# **STATEMENT OF ENVIRONMENTAL EFFECTS**

**PROJECT**  
**SECTION 4.55(1A)**  
**PROPOSED MODIFICATIONS ON**  
**APPROVED DA2020/0864**  
**FOR CHANGE OF FFL OF THE CARPORT**  
**AND THE MATERIAL OF ALFRESCO AREA**  
**FOR THE APPROVED SECONDARY DWELLING**

**PROPERTY**  
**15 PRINCES PROMENADE**  
**SEAFORTH NSW 2092**

**JOB NO**  
**20-15**

Image 1. North East elevation

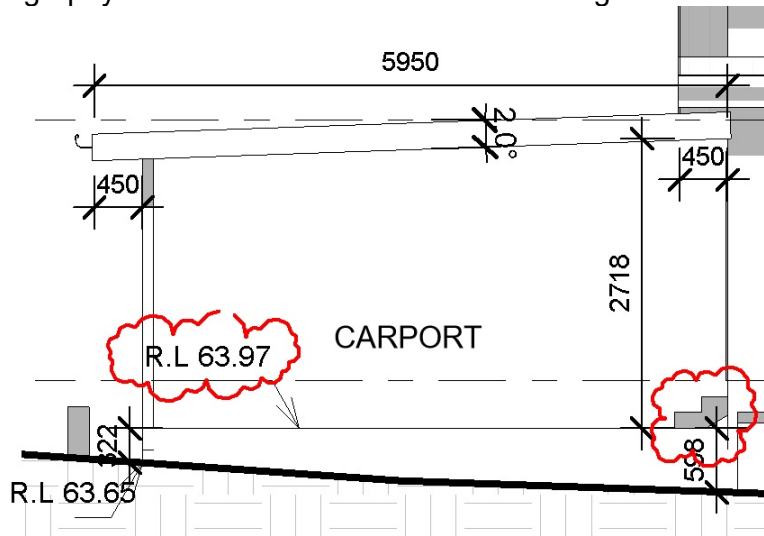
- The approved DA condition 9 states the proposal to address Australian/New Zealand Standard AS/NZS 2890.1:2004 with the elevated parking area. To satisfy the compliance, car barriers and wheel stops will have to be added to the carport which is not desirable outcome for the applicant. The FFL of the carport area is lowered by 300mm to avoid installation of the car barriers. The adjusted FFL is RL63.97 and still works with the existing topography with minor excavation. Refer to image 1 and 2.

Image 3. Additional Steps for the secondary dwelling

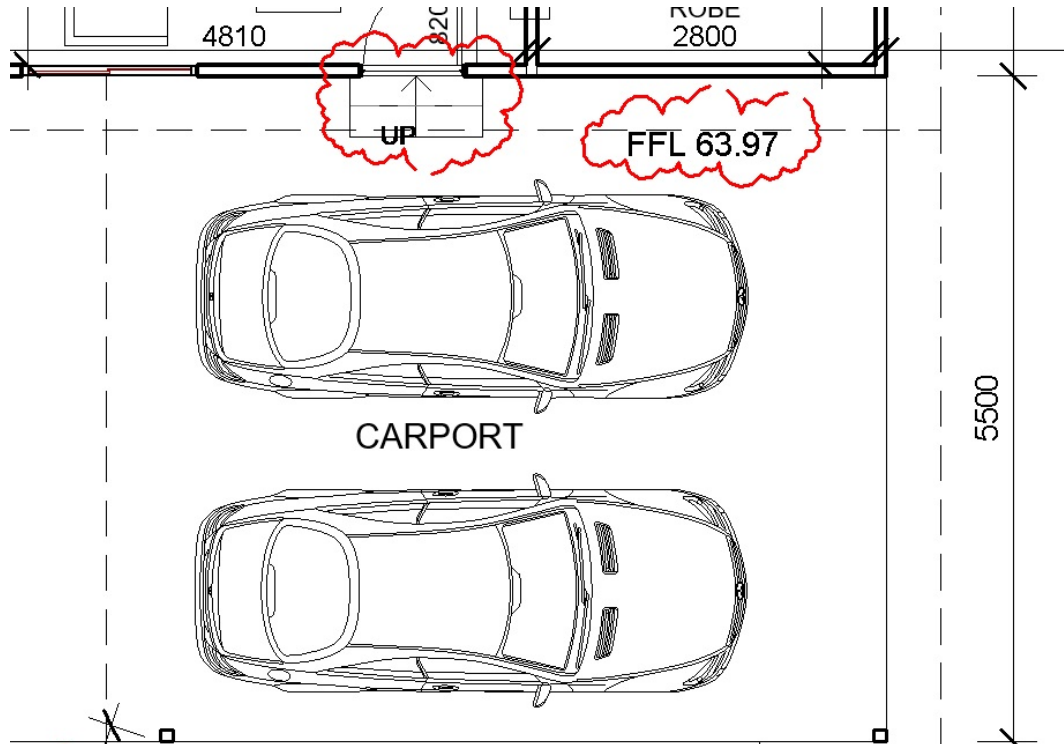
- Additional retaining wall and two steps to the secondary dwelling are added for lower FFL for the carport. The retaining wall requires a minor excavation. Refer to image 3 and 4.

Image 5. Proposed concrete area in front of the carport

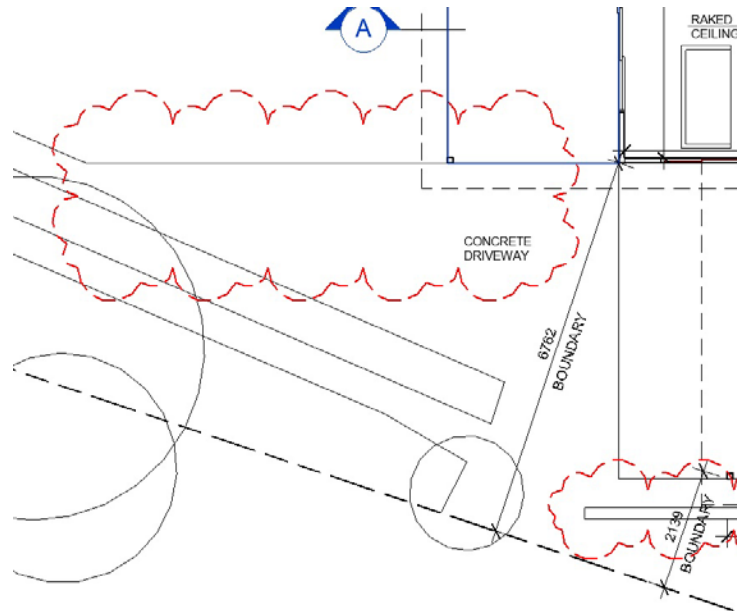
- Additional concrete area for the driveway in front of the carport. The applicant will retain the major area of the existing driveway, however, an additional area is proposed for user convenience. Refer to image 5.

Image 6. Revised material and FFL of the alfresco area.

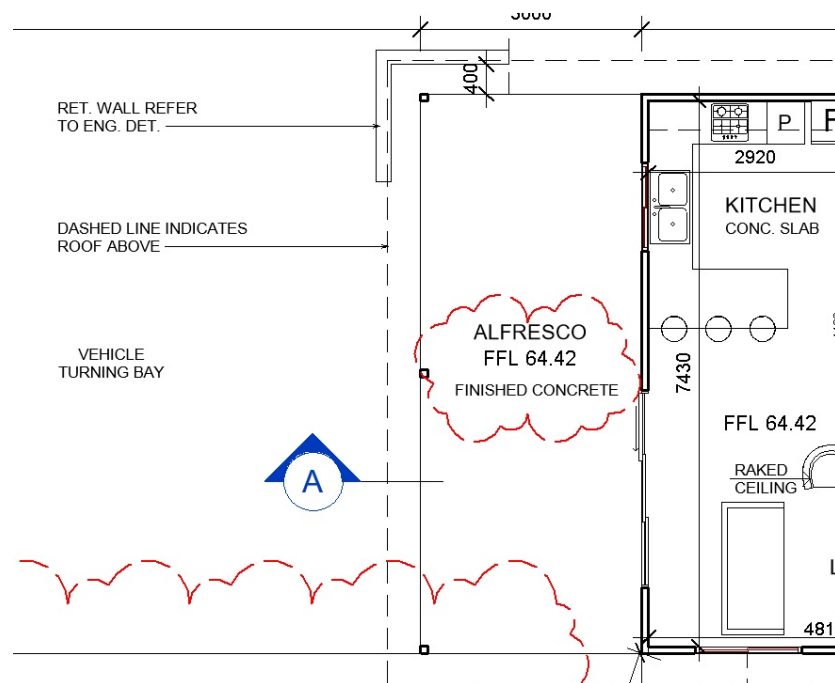
- Recycled Brick for the proposed alfresco area is changed to Concrete slab. The FFL of the alfresco area is raised to 64.42 by to be aligned to the FFL of the approved FFL of the secondary dwelling. Refer to image 6.
